# Appendix J

## Comments and Responses

This appendix contains responses to comments received on the Draft Environmental Impact Statement/Environmental Impact Report (EIS/EIR), including all written comments received during the comment period and oral comments submitted at public meetings. The comment letters are included in Appendix O.

Long-Term Water Transfers  
Final EIS/EIR

**Figure J-2. Extent of Tuscan and Tehama Formations with respect to groundwater substitution pumping under Proposed Action**

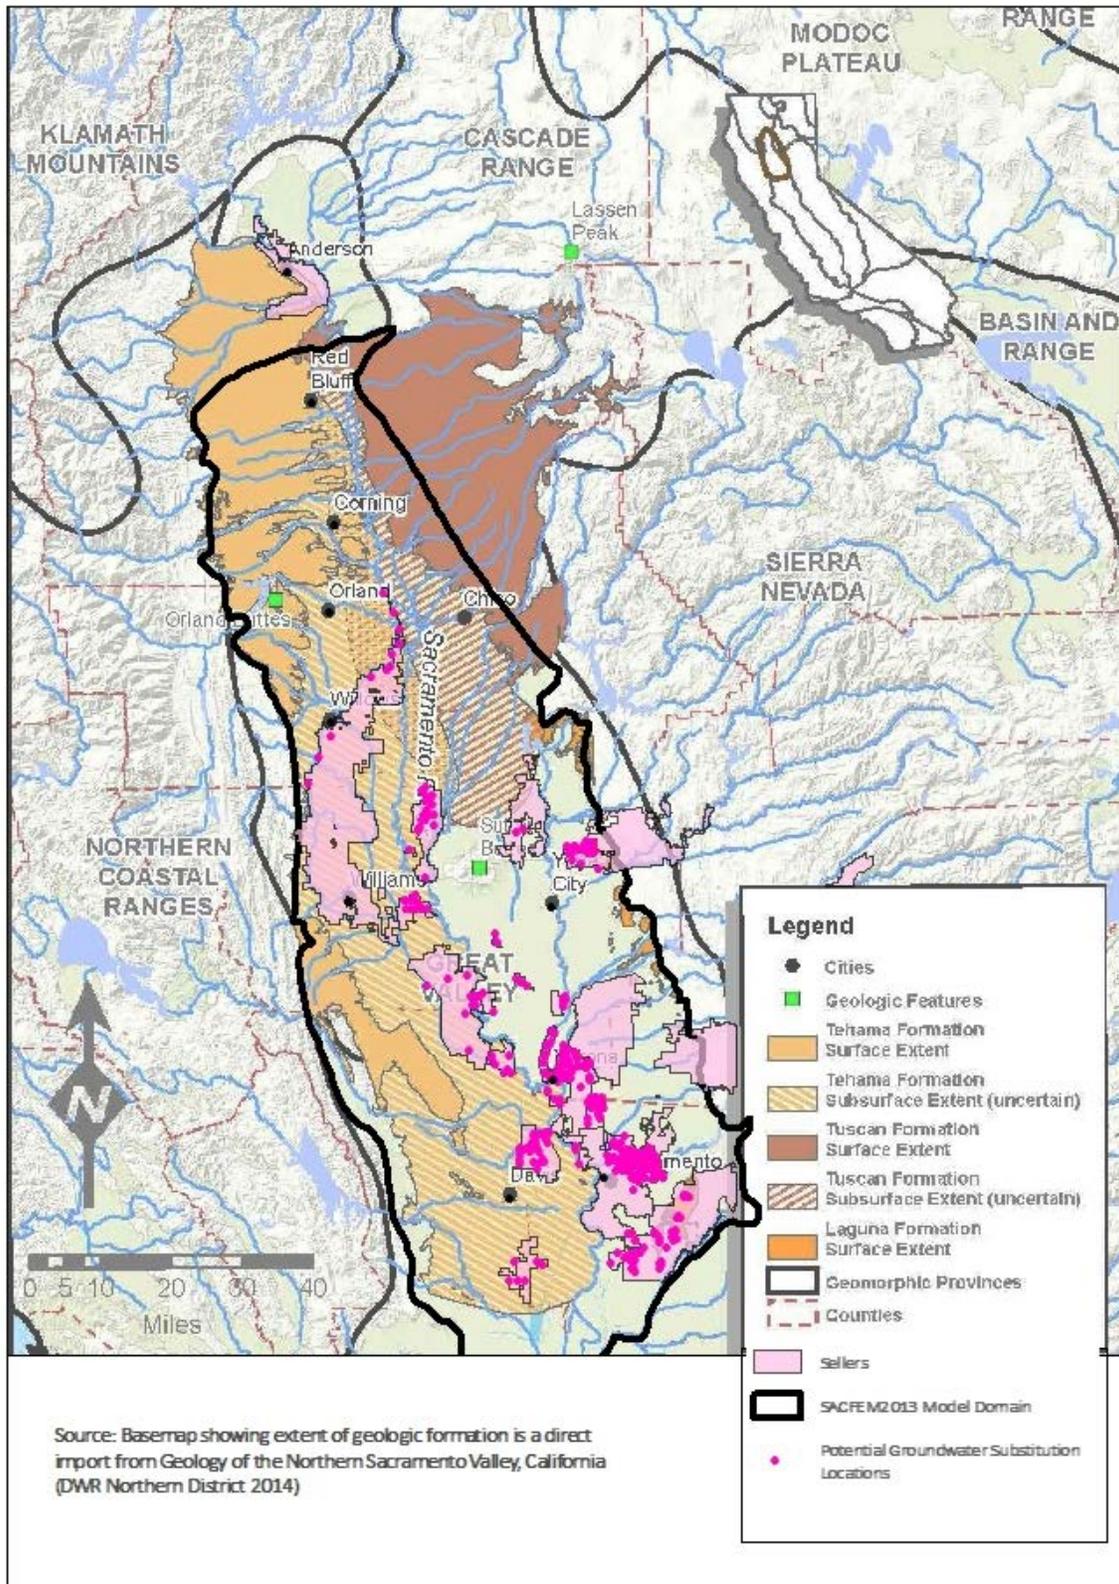
Commenters expressed concerns that transfer-related pumping would be concentrated in the Tuscan Formation. As shown in Figure J-2, groundwater substitution pumping associated with the range of potential activities analyzed under the Proposed Action would occur primarily outside the Tuscan formation, either from the Tehama Formation or other formations not identified in Figure J-2. Some of the groundwater substitution pumping wells for Glenn-Colusa Irrigation District, Reclamation District 1004, and Butte Water District lie within (or near) the potentially disputed Tuscan and Tehama subsurface formations. Pumping from these wells will be closely monitored through the implementation of Mitigation Measure GW-1 to avoid potentially adverse effects. Refer to Common Response 6 for a discussion of revisions to Mitigation Measure GW-1 in response to public comments.
